# NORTH WEST **cambridge**

Section 73  
Design Statement  
September 2013

This Design Statement accompanies a Section 73 application made by the North West Cambridge Project Team on behalf of the University of Cambridge in relation to the outline consent for North West Cambridge scheme (11/1114/OUT and S/1886/11).

- Condition 69: Drawing Numbers –revised Parameter Plans will be submitted as part of the Section 73 Application, to address amendments to the heights in the local centre and revised positioning of the Community Centre through detailed design.

Approved Parameter Plan 03/A, February 2013

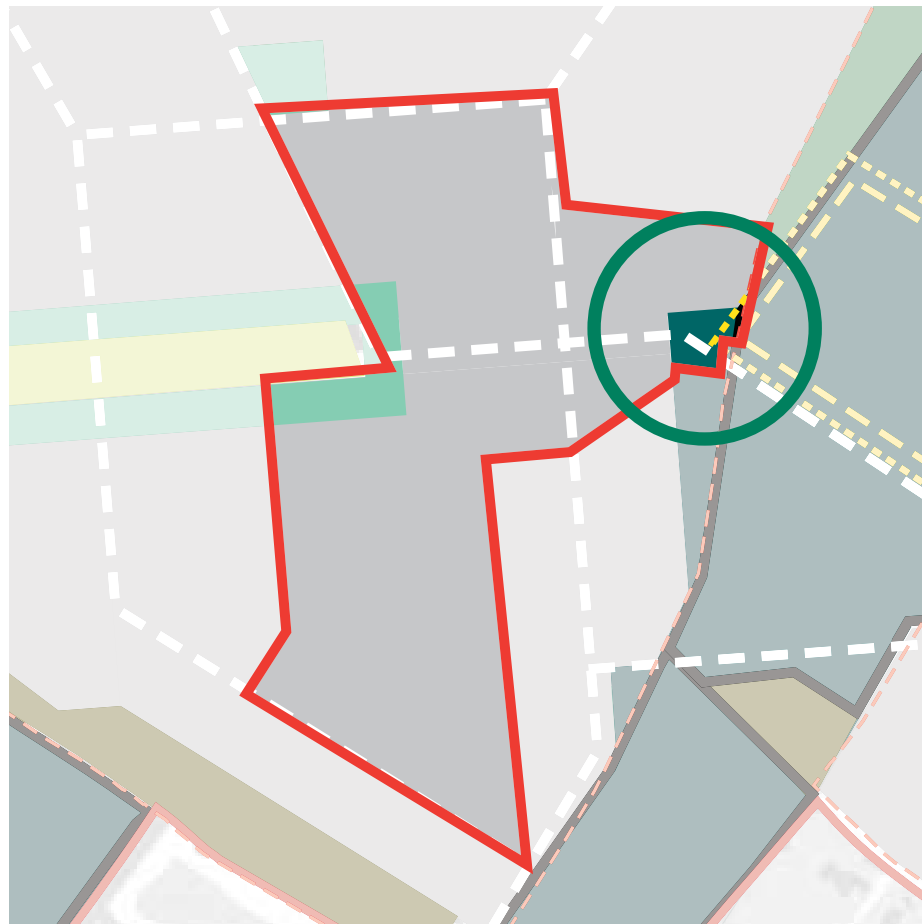
Design development for the Community Centre for North West Cambridge requires that the building extends into a small area of Primary Open Land immediately to the south of Lot 7. Therefore it is proposed to amend the parameter plan to reflect this. This building also requires a building height parameter that will be modified on the heights and zone parameter plans as described above. Please refer to Chapter 4, Section 4.1.6 for documentation of the consultation and evolution of Lot 7 design.

Proposed Parameter Plan 03/B, September 2013

Approved Parameter Plan 04/A, February 2013

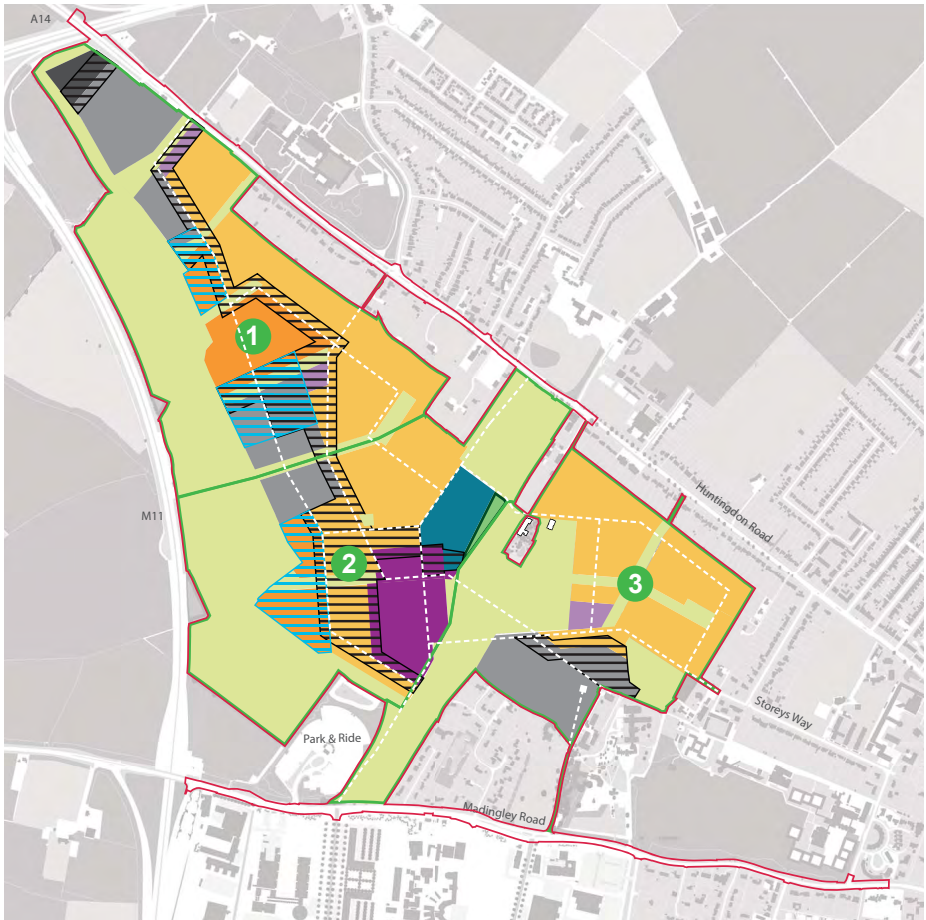
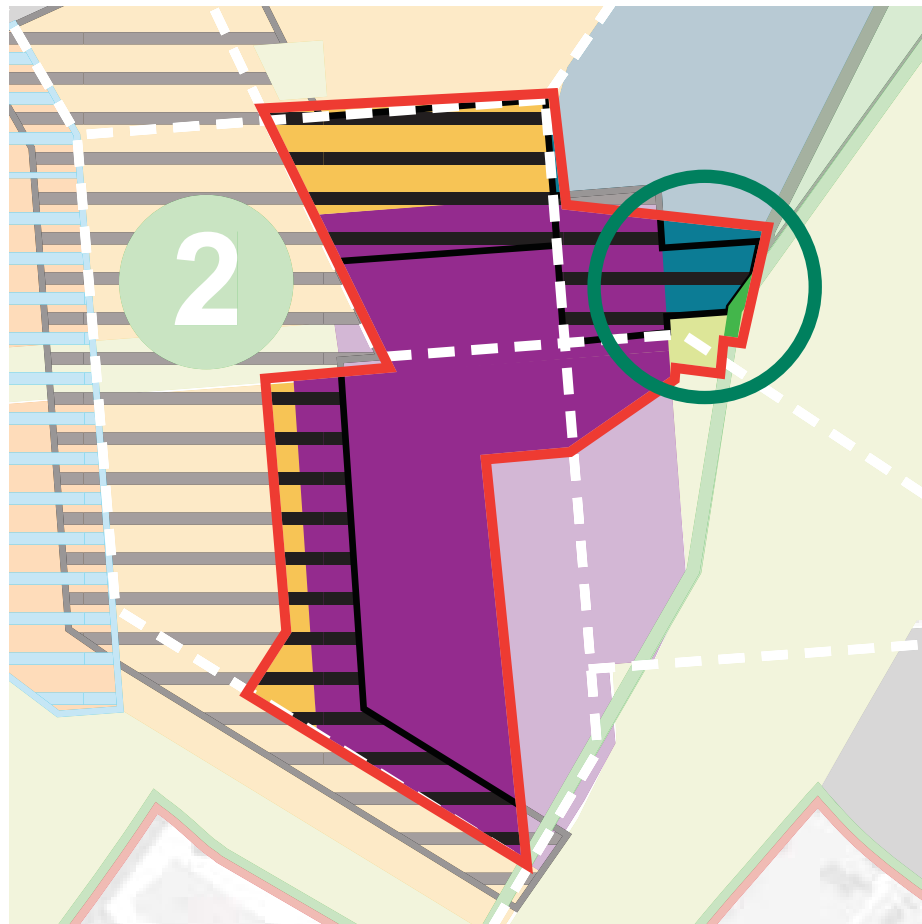
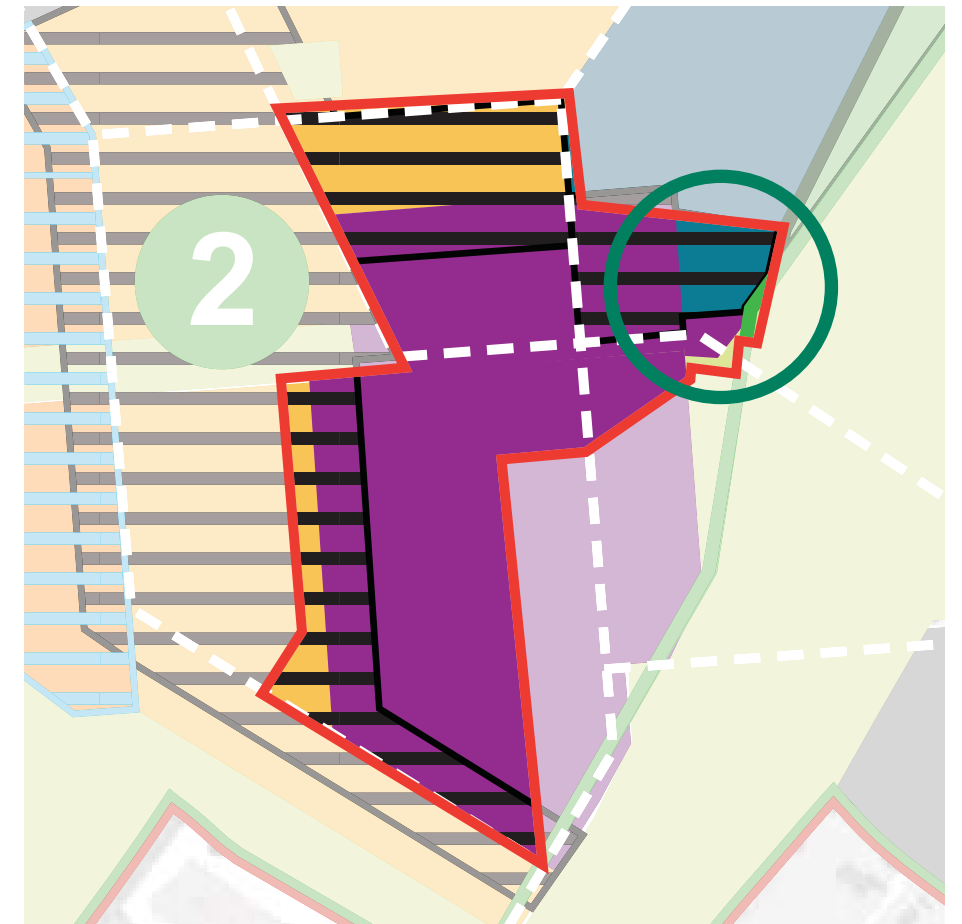
Design development for the Community Centre for North West Cambridge requires that the Community Centre building extends into a small area of primary open land immediately to the south of Lot 7. Therefore it is proposed to amend the parameter plan to reflect this.

Proposed Parameter Plan 04/B, September 2013

Approved Parameter Plan 05/A, February 2013

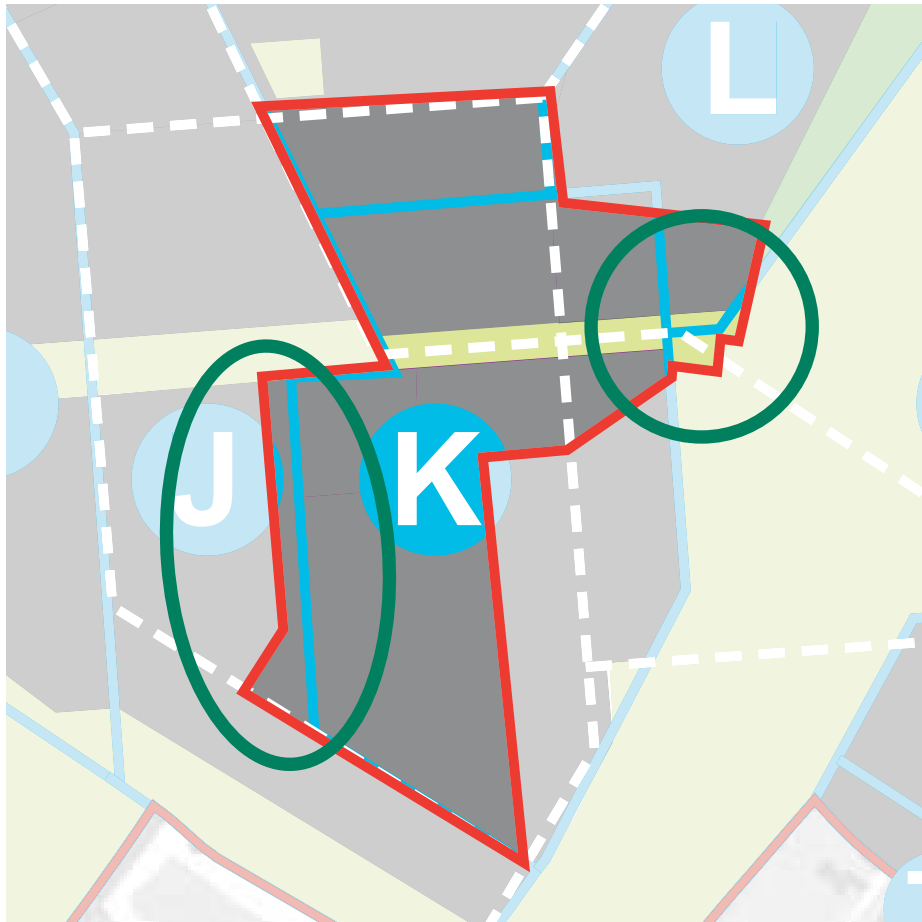
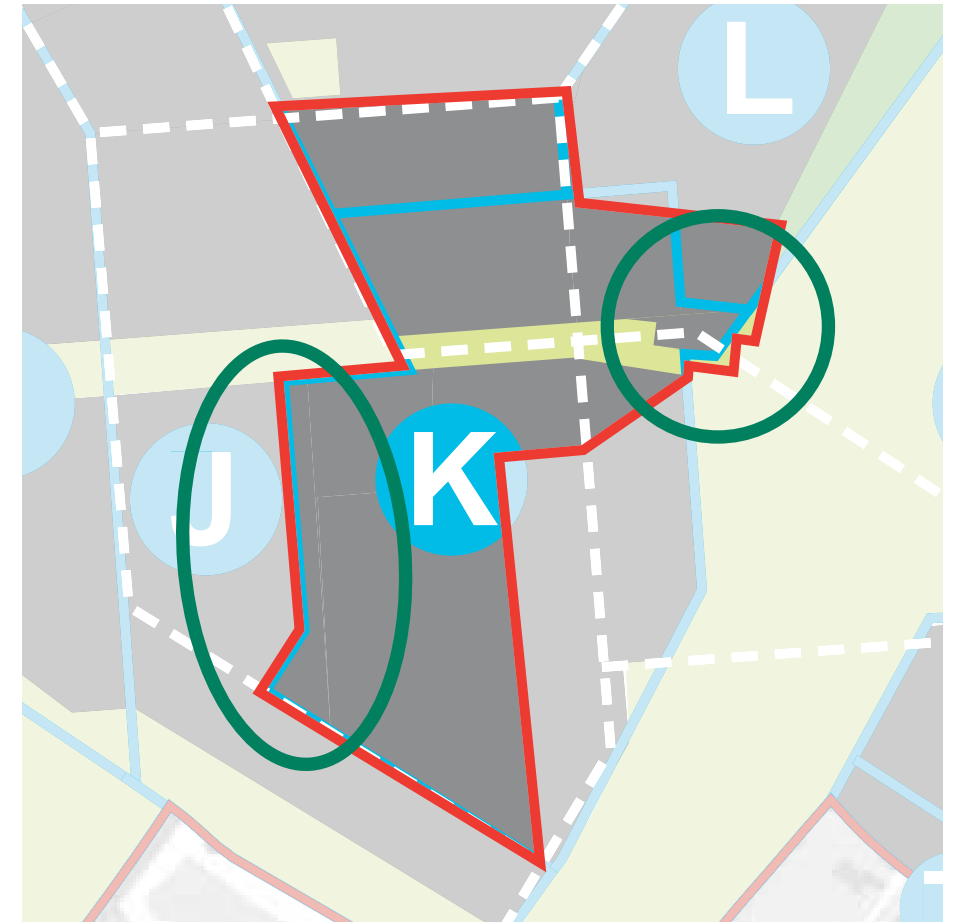
All other components of the Outline Planning Consent remain unchanged.

Proposed Parameter Plan 05/B, September 2013

Approved Parameter Plan 06/A, February 2013

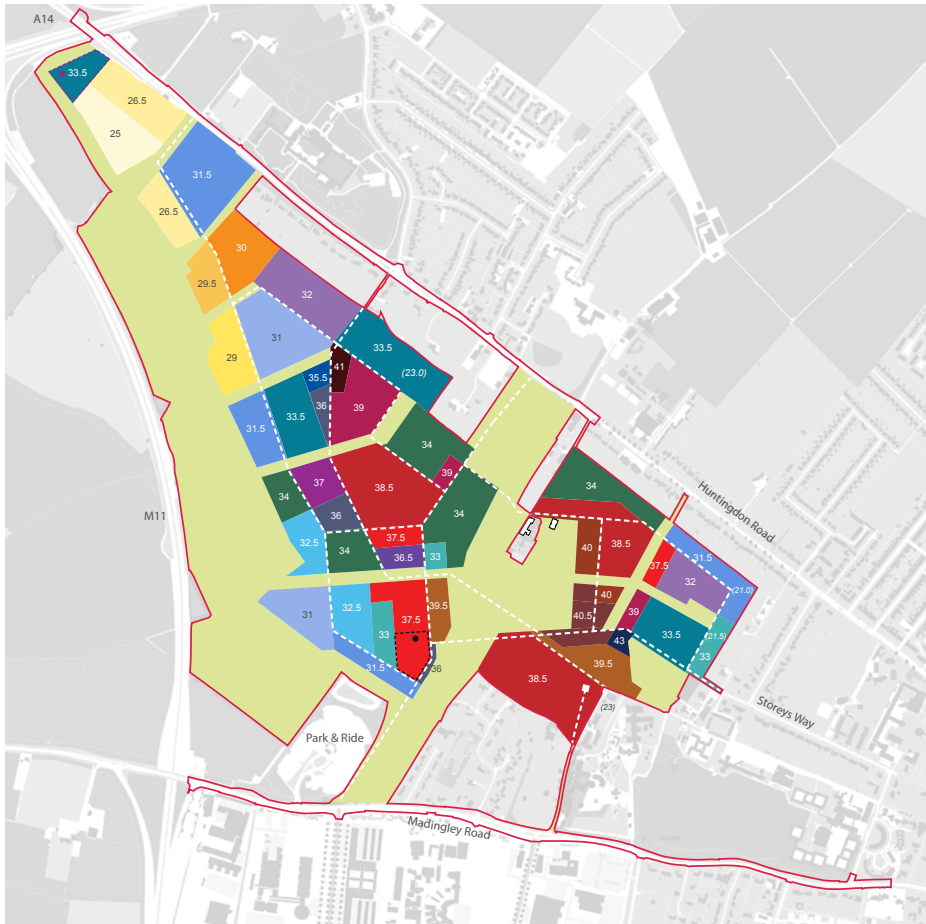
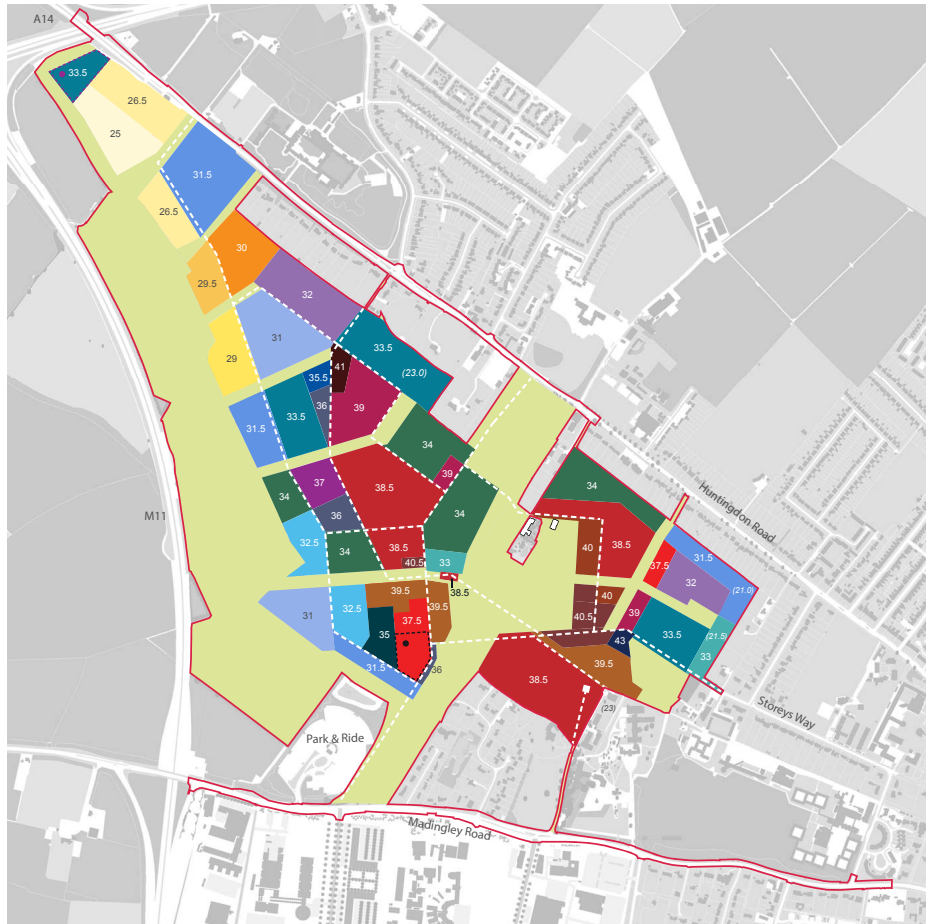
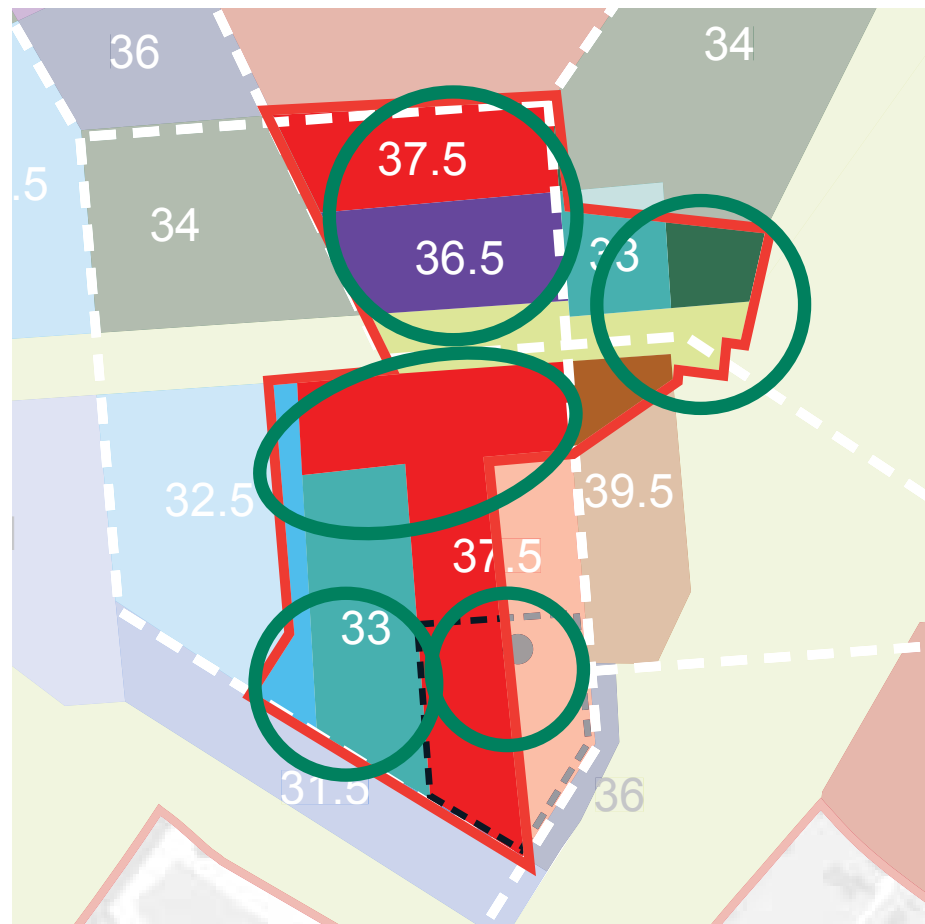
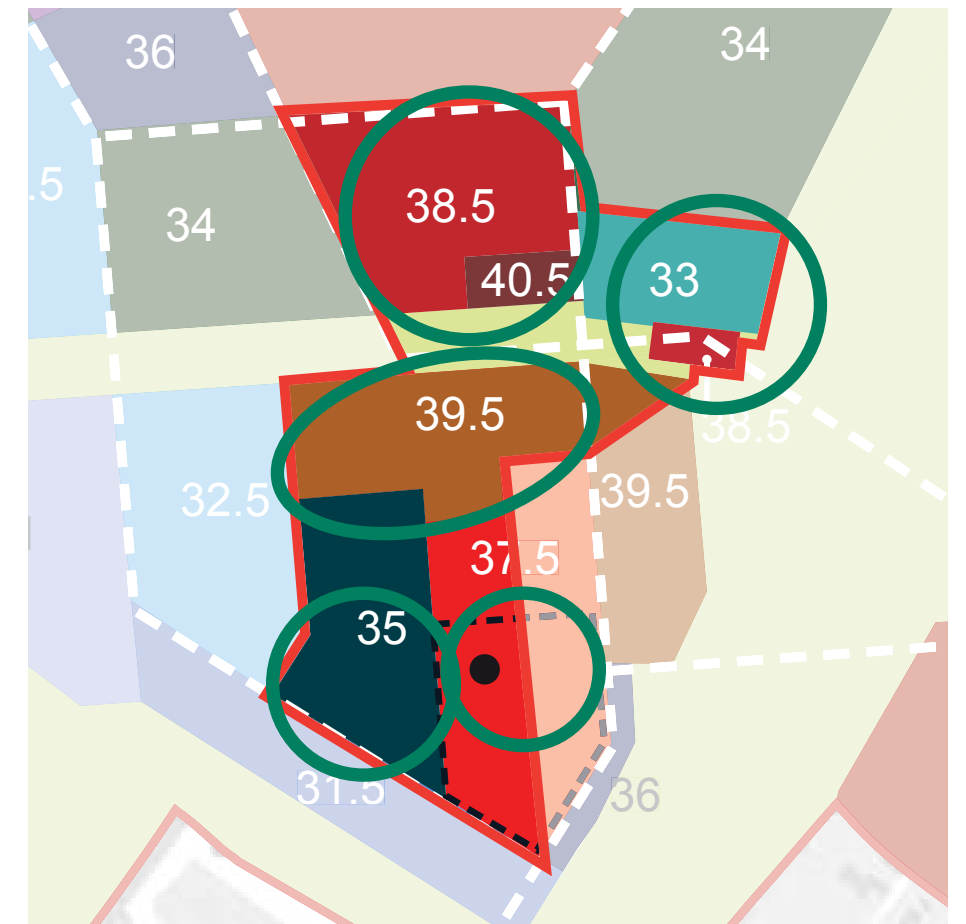
In addition, due to the detailed design of the Community Centre (Lot 7), its location now extends into the Primary open land set out in the Open Land and Landscape Areas Parameter Plan (NWC/OPA/PAR/03). The building heights parameter plan therefore includes a new discrete area of development with a maximum building height of 38.5m.

Due to technical requirements the energy centre flue size is required to be larger than previously anticipated. It is therefore proposed that the height for the energy centre flue on the parameter plan is increased by 2m, with an increased dimension of 5.0 x 5.8m, which reflects a square chimney rather than a circular chimney.

Proposed Parameter Plan 06/B, September 2013

Zone for Energy Centre flue of 5.0 x 5.8 m in plan dimension and height 44.5m AOD

Approved Parameter Plan 07/A, February 2013

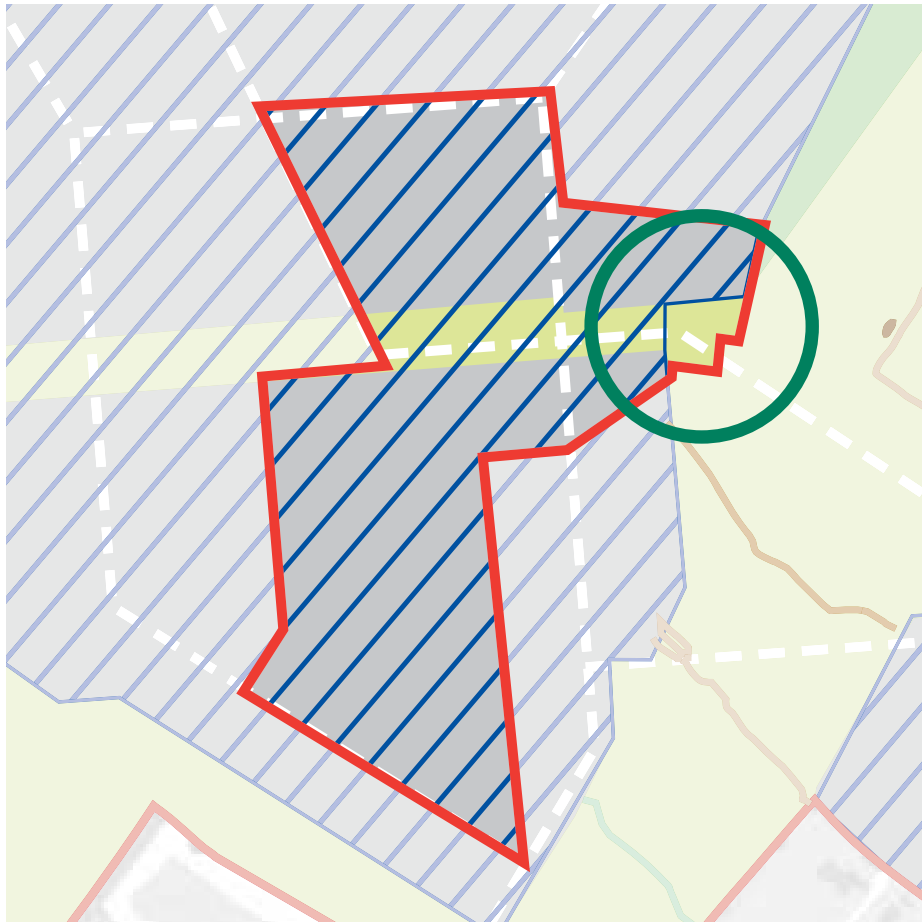
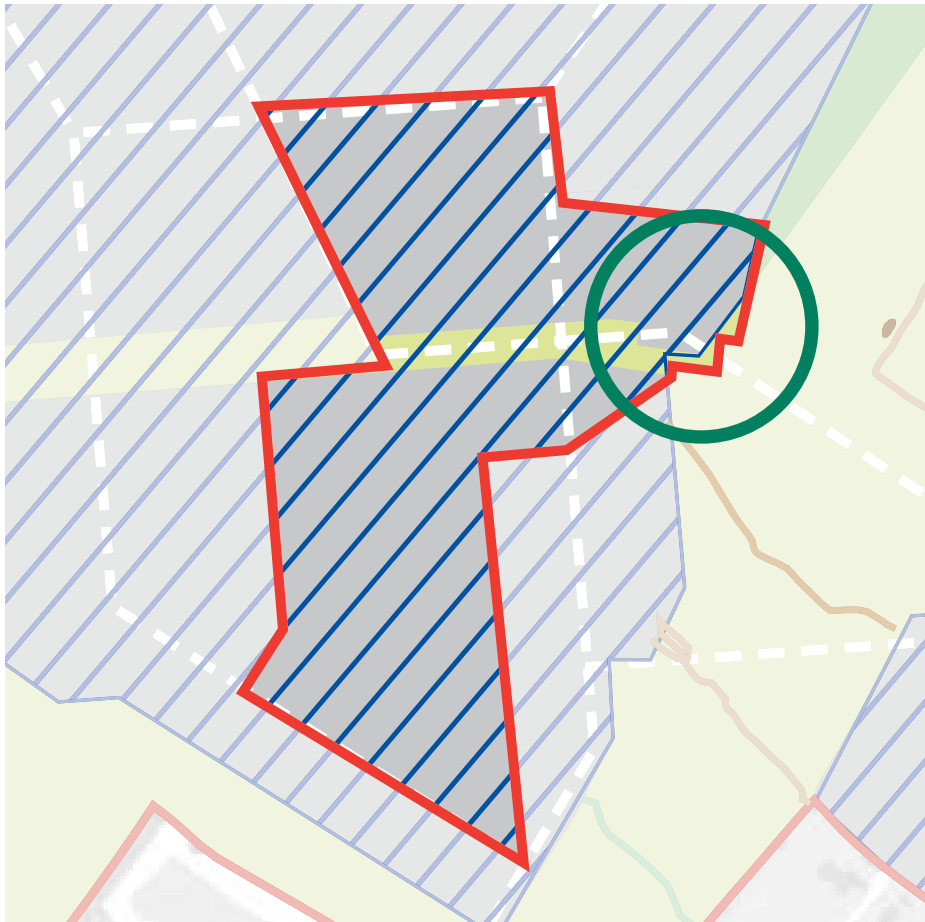
Design development for the Community Centre for North West Cambridge requires that the Community Centre building extends into a small area of primary open land immediately to the south of Lot 7. Therefore it is proposed to amend this parameter plan to reflect an extended development area around Lot 7 to include the Community Centre building in its entirety.

Proposed Parameter Plan 07/B, September 2013
